Addendum

March 8, 2023

Weston Town Green Improvements

The following are clarification and response to questions that were brought up during the March 7, 2023 pre-bid site meeting and/ or submitted in writing to the Town.

MEMORIAL PLAQUES

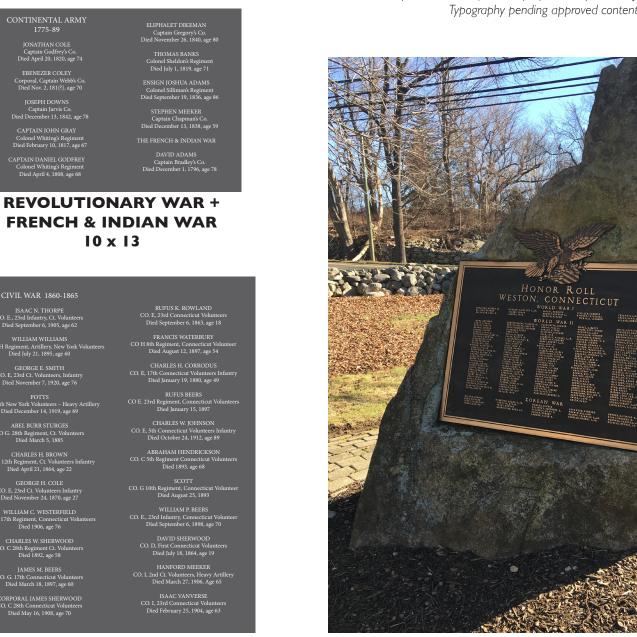
- 3. Fabricator would like better detail on the monument plagues and the material they will be made of as well as the amount of script to be engraved.
 - 1. See the attached PDF for the plaque sizes. Plaques Shall be Bronze to match the existing Honor Roll Plaque.

CIVIL WAR 24 x 16

WWI, WWII, KOREA (existing) 30 x 40

VIETNAM (existing) 12 x 24

PERSIAN GULF (existing) 12 x 16

IRAQ & AFGHANISTAN 10 x 13
